RECORD OF TECHNICAL CHANGE

Technical Change No. ROTC CAP-1

Project/Job No. Corrective Action Unit 224

Project/Job Name Corrective Action Unit 224: Decon Pad and Septic Systems

FIGURE 5.
 CAS 06-05-01, LEACHFIELD; CAS 06-17-04, DECON PAD AND
 WASTEWATER CATCH; AND CAS 06-23-01, DECON DISCHARGE PIPING

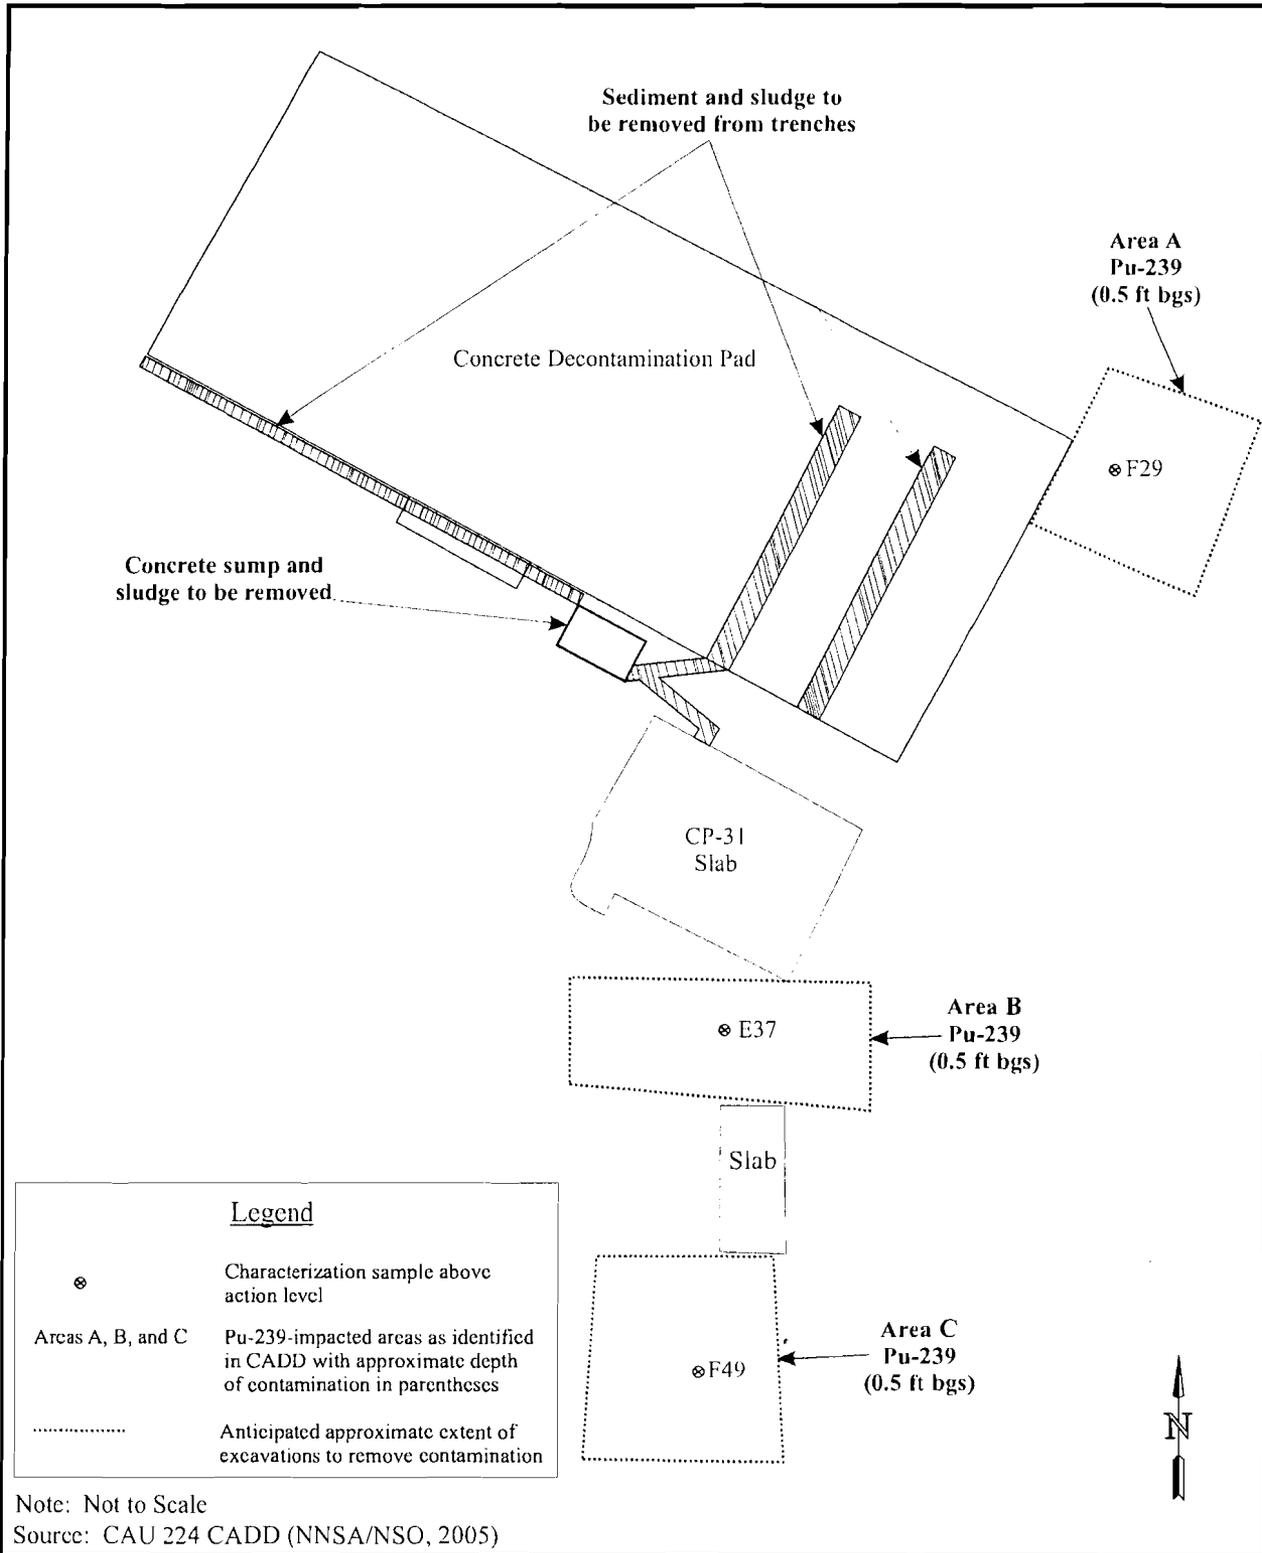
6. **Page 11 – Replace Figure 5 with the attached Figure 5.**
7. **Page 12, first paragraph – Replace the first, second, third, and fourth sentences with the following text:**
After the planned volume of soil has been removed, a minimum of two soil verification samples will be collected from the base of each excavation. Samples will be analyzed for isotopic Pu to verify that the remaining soil is below the action level.
